Errata Sheet

Product Family: DL305
Manual Number D3-ANLG-M
Revision and Date 3rd Edition, February 2003

Changes to Chapter 3. F3-04ADS 4-Channel Isolated Analog Input

Page 3-3. Setting the Module Jumpers; Jumper Locations

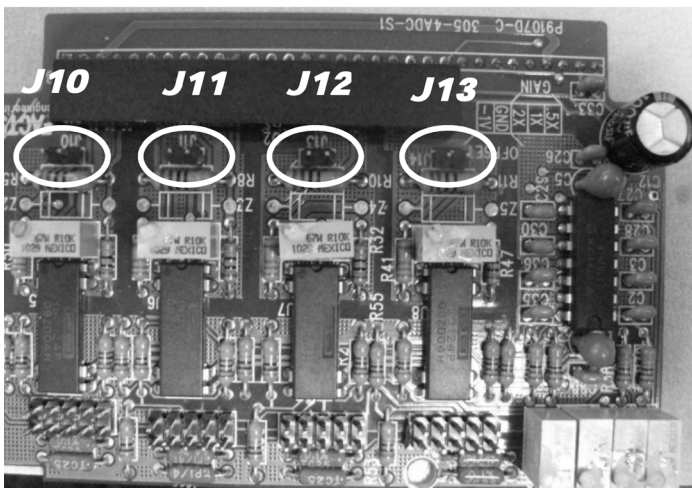
The PC board was redesigned and the locations of jumpers J10, J11, J12, and J13 changed. The jumpers were rotated 90 degrees and are closer to the back of the module than the original layout. The functionality of the jumpers did not change. The orientation of the 5 pairs of pins for each channel is the same.

The photo on the right shows the new design, while the one on the left shows the original PC board. The photo on the left matches the drawing shown on page 3-3. The redesigned PC boards are in modules manufactured starting in mid-2012.
